# UNITED STATES PATENT AND TRADEMARK OFFICE

10/539,109

<b>Office Action Summary</b>	<b>Application No.</b> 10/539,109	<b>Applicant(s)</b> YOSHINO ET AL.	
	<b>Examiner</b> Quang T. Van	<b>Art Unit</b> 3742

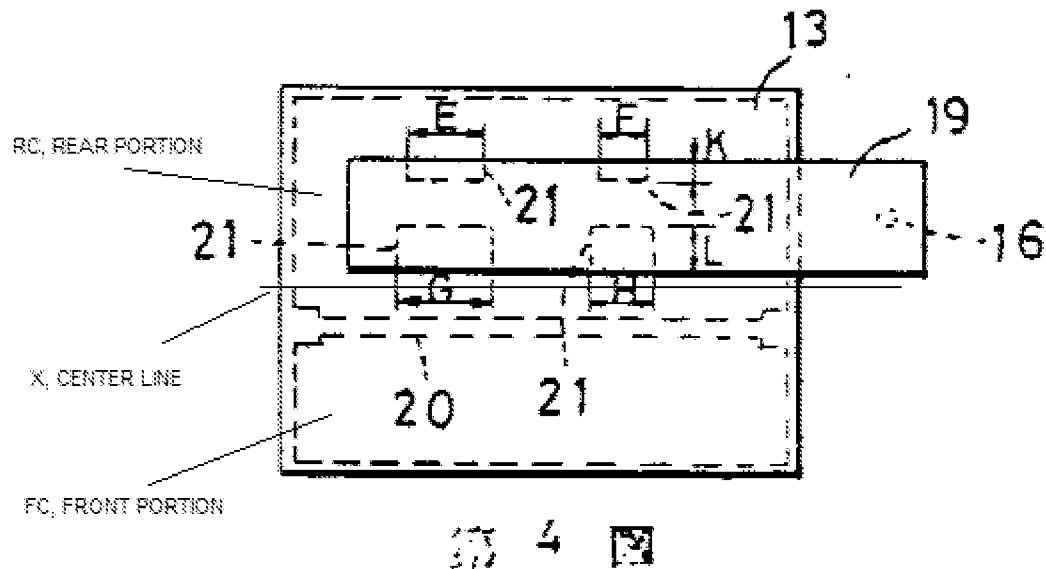
5. Claims 1, 3, 8, 11-14 and 16 are rejected under 35 U.S.C. 103(a) as being unpatentable over McCammon et al (US 4,556,772) in view of JP 63174296A, cited by applicant. McCammon discloses a microwave oven cavity air flow system comprising a magnetron (30, figure 3) to a heating chamber (12) via a waveguide (34), wherein an electricity feeding port (64) for radiating the microwave is provided at a ceiling wall (20) of the heating chamber (12), and the wave guide (34) is formed in an L-like shape including a side waveguide (34b) extended upwardly along an outer side face (14) of

the heating chamber (12) such that the side waveguide (34b) is in direct contact with the outer side face of the heating chamber (12) and an upper waveguide (34a) extended from an upper end of the side wave guide (34b) to the electricity feeding port (64) along an outer face of the ceiling wall (20). However, Yoshimura does not disclose a plurality of pieces of the electric feeding ports feeding ports, wherein when the plurality of electricity feeding ports are aligned in a front and rear direction of the ceiling wall, the opening area of the electricity feeding port at a position proximate to a center of the ceiling wall is set to be larger than the opening area of the electricity feeding port at a position remote from the center of the ceiling wall, the opening area of the electric feeding port at a position proximate to the center of the ceiling wall reaches one end of the waveguide, and the opening area of the electricity feeding port at a position remote from the center of the ceiling wall does not reach the other end of the waveguide. JP 63174296A discloses a plurality of pieces of the electric feeding ports (17, 21, Figures 1-5), wherein the plurality of electricity feeding ports (17, 21) are formed by at least two or more kinds of electricity feeding ports having different shapes and opening areas (Figure 1-5), wherein when the plurality of electricity feeding ports (17, 21) are aligned in a front and rear direction of the ceiling wall, the opening area (G) of the electricity feeding port (21, Figure 4) at a position proximate to a center of the ceiling wall is set to be larger than the opening area (E, Figure 4) of the electricity feeding port at a position remote from the center of the ceiling wall (Figure 4), the electricity feeding ports (21, Figure 4) are mounted to the ceiling wall, the electricity feeding ports (21, Figure 4) being mounted at a position away from a line (X, Figure below) equally dividing the

ceiling wall into two in a front (FC, Figure below) and rear (RC, Figure below) direction, the opening area of the electric feeding port (G, Figure below) at a position proximate to the center (X, Figure below) of the ceiling wall reaches one end of the waveguide (19), and the opening area of the electricity feeding port (E) at a position remote from the center (X, Figure below) of the ceiling wall does not reach the other end of the waveguide (19). It would have been obvious to one having ordinary skill in the art at the time the invention was made to utilize in Yoshimura a plurality of pieces of the electric feeding ports feeding ports, wherein the plurality of electricity feeding ports are formed by at least two or more kinds of electricity feeding ports having different shapes and opening areas, wherein when the plurality of electricity feeding ports are aligned in a front and rear direction of the ceiling wall, the opening area of the electricity feeding port at a position proximate to a center of the ceiling wall is set to be larger than the opening area of the electricity feeding port at a position remote from the center of the ceiling wall, the opening area of the electric feeding port at a position proximate to the center of the ceiling wall reaches one end of the waveguide, and the opening area of the electricity feeding port at a position remote from the center of the ceiling wall does not reach the other end of the waveguide, as taught by JP 63174296A in order to distribute temperature uniformly throughout the heating chamber. With regard to claim 8, JP6317296A also discloses a heating member in a linear shape (20, Figure 4) for heating by a heater is mounted to the ceiling wall of the heating chamber (12) and the electricity feeding ports (21, Figure 4) are mounted to the ceiling wall, both the heating member (20, Figure 4) and the electricity feeding ports (21, Figure 4) being mounted at

a position away from a line (X, Figure below) equally dividing the ceiling wall into two in a front (FC, Figure below) and rear (RC, Figure below) direction.
